DOCUMENT NUMBER:	MTN-0166-24
ISSUE DATE:	2024-12

MOTOROLA SOLUTIONS TECHNICAL NOTIFICATION (MTN)

Alarms from SDM3000 RTU and MC-EDGE NFM devices are classified incorrectly in the UEM.

ASTRO® 25

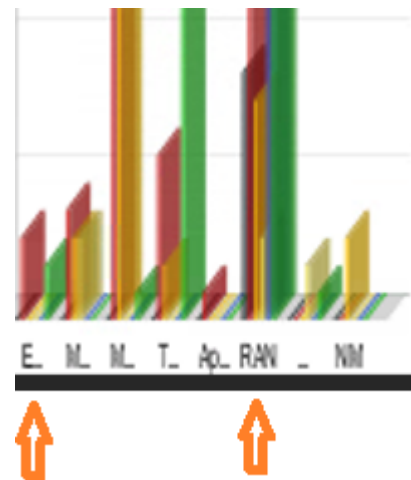
Alarms reported for *Environmental Mixed* entities of SDM3000 RTU and MC-EDGE NFM devices are classified in the wrong device category in the UEM (*RAN* instead of *Environmental*). As a result, the statistics related to these alarms are displayed in an incorrect section of the *Alarm Summary View* bar graph (see the screenshots below).

Upgrade to the appropriate version as listed in the "Software/Hardware Parts Required" section below, based on the model.
